SUBMITTAL IDENTIFICATION SHEET

WEBSTER UNIVERSITY ISB
PROJECT NAME

057100-008
CONTRACTOR / CM SUBMITTAL NO.

Subject: Stair 1 Submittal

SECT. "G"
DWG. E100

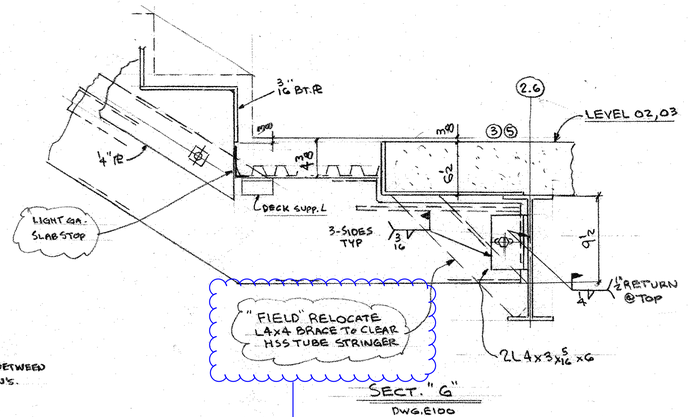
verify with CM that no re submittal required to structural for corrective work

GLASS GUARDRAILS AND GRABRAILS

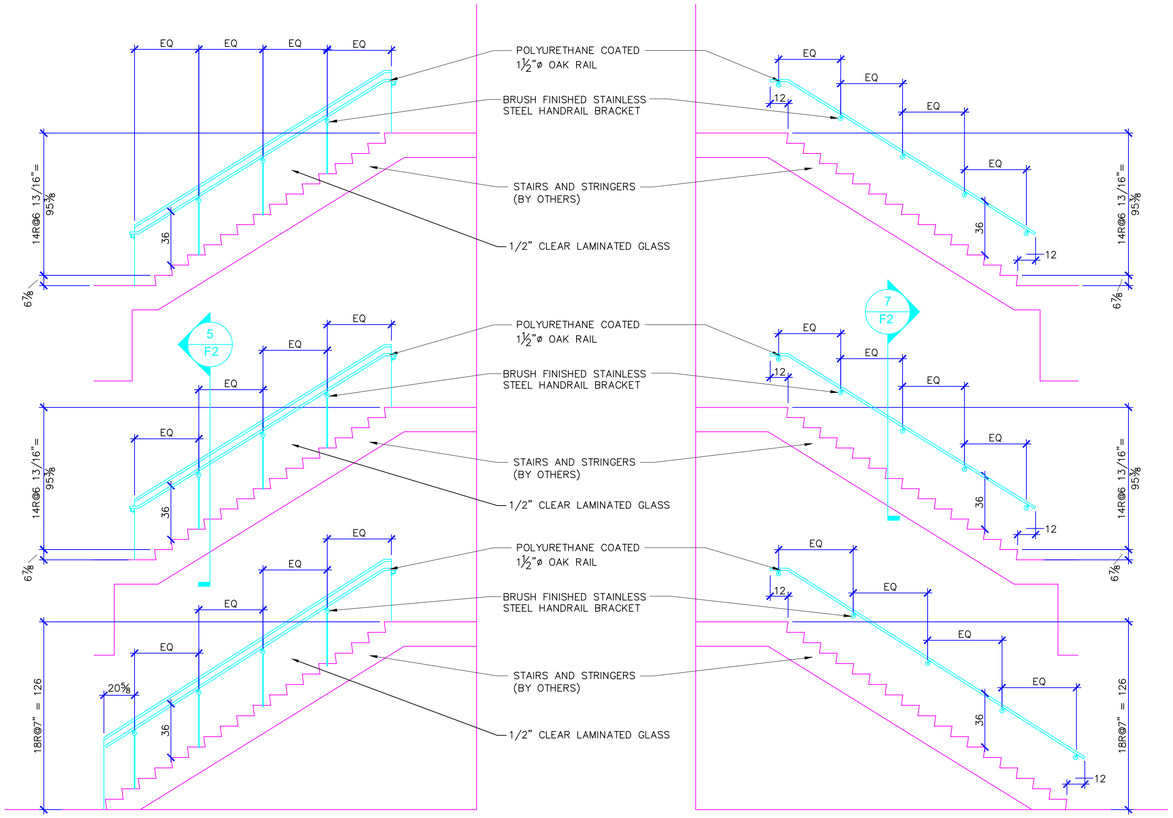
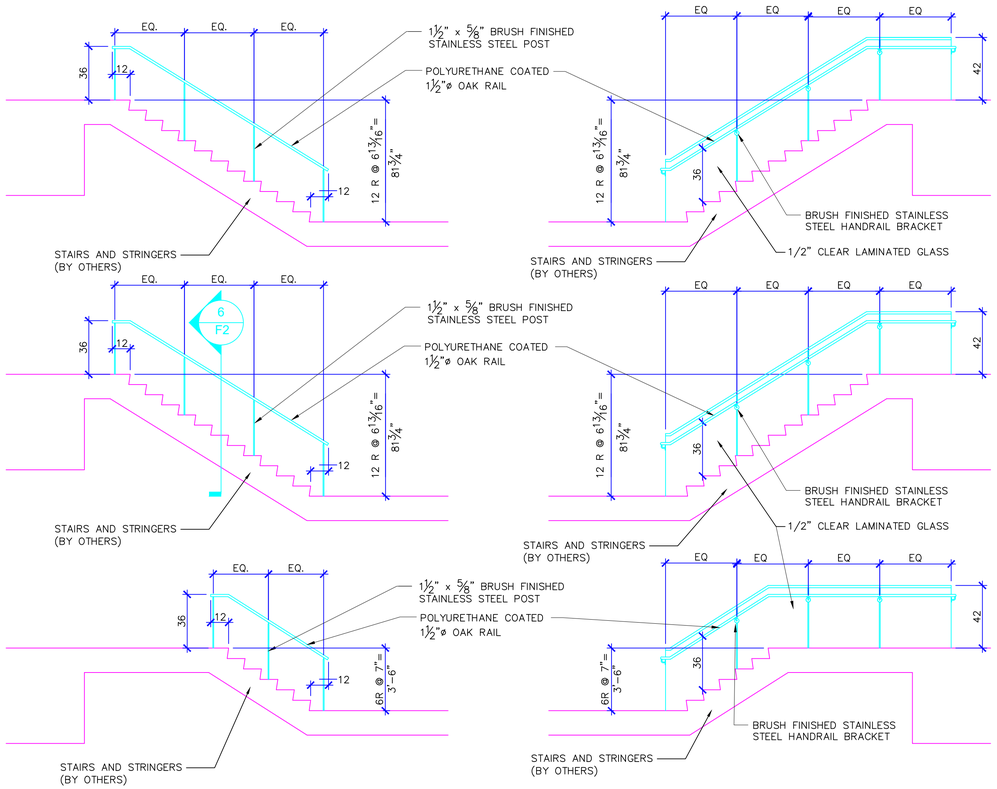
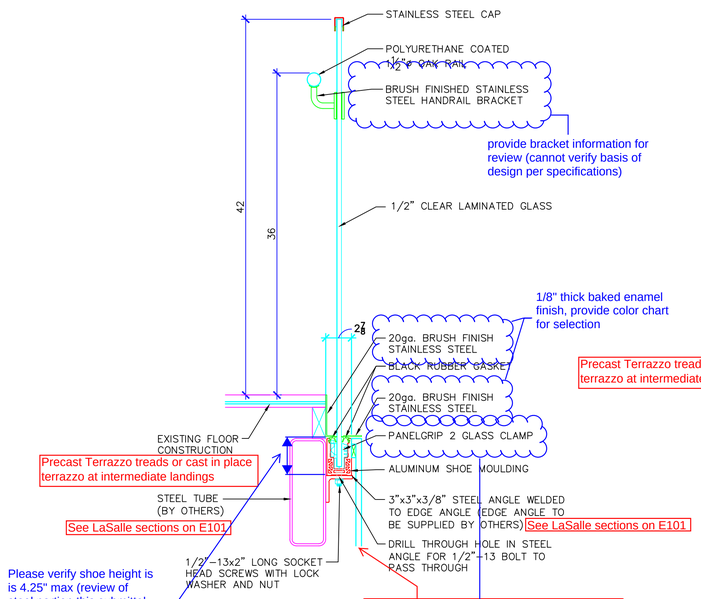
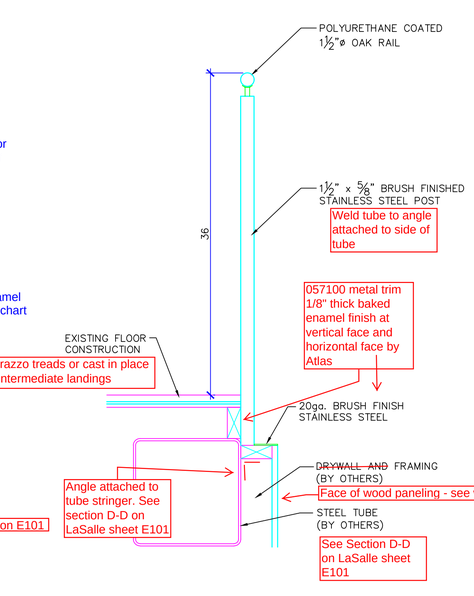
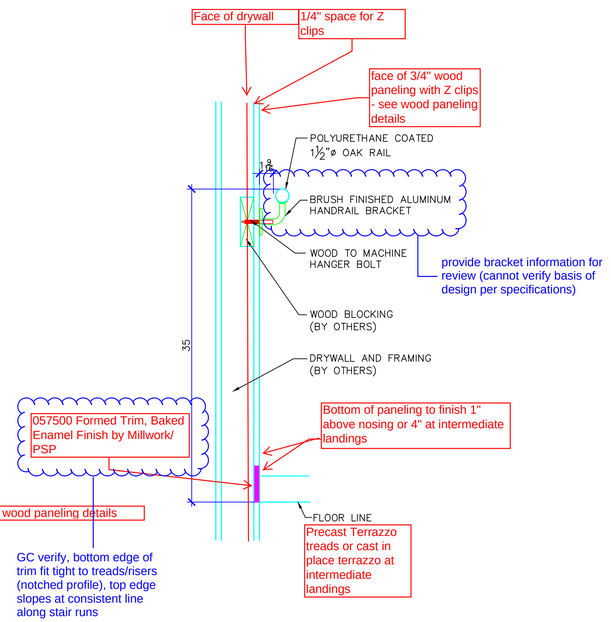
include all details for review, cannot verify design intent at vertical to horizontal transitions, stair to wall transitions, stair to landing, etc.

3/07 Elevation at Panels Under Stairs
3/8"=1'-0"

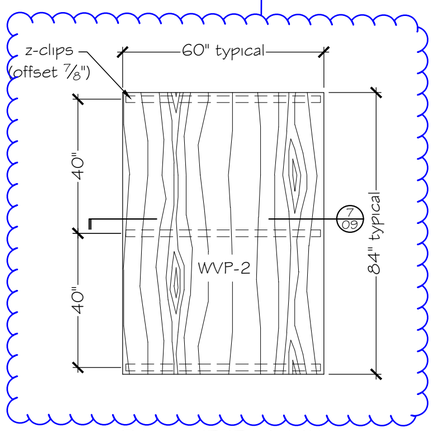
verify size in field

this will likely end up as 7/8" hat channels to hold 1'-4" dimension at runs based on steel dimensions shown

7/09 Section at Underside of Stairs
1 1/2"=1'-0"

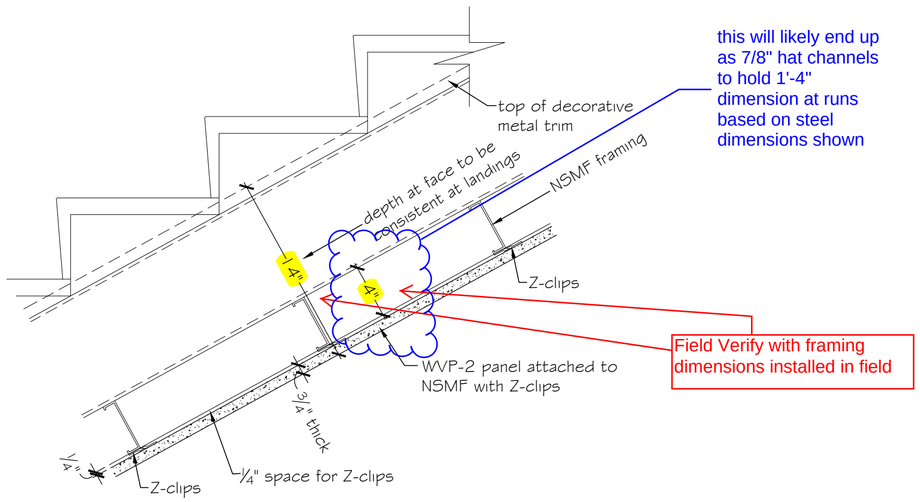
Need to see joint layout and grain direction of all panels specific to this project (RCP each floor), not just typical sizing. Locate sprinkler heads for design intent verification (ref. A0501.B)

confirm that this dead load is accounted for in stair design (does not appear to be included in submittal 05 7100 009 page 4 list of loads)
